SUSTAINABLE SEAFOOD PROJECT PART 2:

Good Manufacturing Practices (GMPs) and Operational Pre-Requisite Programmes (OPRPs) Inspections of the Naduri Ice Plant.

The Consultant: Dr Jimaima Lako

December 2015

H. Hand washing facility outside the building

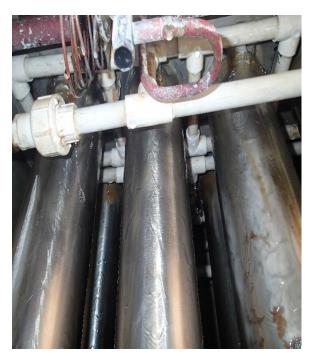
3. Did not see the employee wash or sanitize hands before touching	٧	
ice. The improper hand washing facility as shown in Appendix H, is		
outside the work station without hand wash signs posted.		
outside the work station without hand wash signs posted.		
Recommendation:		
The hand washing facility needs to be upgraded with a proper wash basin		
and tap operated by elbow or leg and to be furnished with paper towel or		
air-hand dryer and soap. Wash hand signs to be posted at the hand wash		
stations.

17. No hand washing observed when the employee touched the contact		
surfaces as the hand washing facility is not within the production		V
facility but only available outside the building as discussed in 3		
above.		
Recommendation:		
The hand washing facility to be located inside and close or within the		
production area for easy access and needs to be upgraded with a proper		
wash basin and tap operated by elbow or leg and to be furnished with paper		
towel or air-hand dryer and soap. Wash hand signs to be posted at the hand		
wash stations.	1	-1
